# Town of Gorham Planning Board Meeting June 6, 2022

**ITEM 4** – Site Plan Review: Leaf Labs LLC – Marijuana Grow and Distribution Facility – a request for site plan review of a 40, 900 sq. ft. industrial building with associated infrastructure on 65 Olde Canal Way. Zoned OCI, Map 134, Lot 3-3. The applicant is represented by Craig Burgess, P.E., of Sebago Technics, Inc.

**Wright Pierce:** 05/26/2022

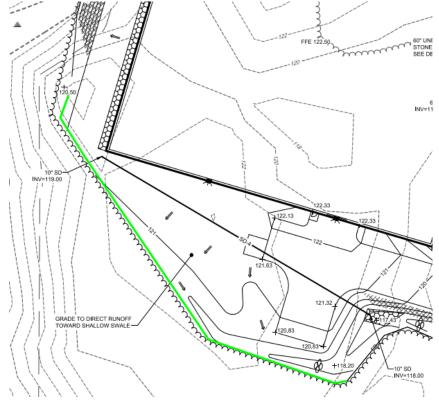
- 1. Environmental
  - a. Filter berm is proposed as a perimeter erosion control. The southerly filter berm should be extended to tie into the westerly mound for additional erosion and sedimentation protection. Soil disturbances for grading of the shallow swale and trenching for storm drain (SD-4) would likely result in sediment transport off-site as currently proposed. See sketch of

approximate location with the extension shown in green.
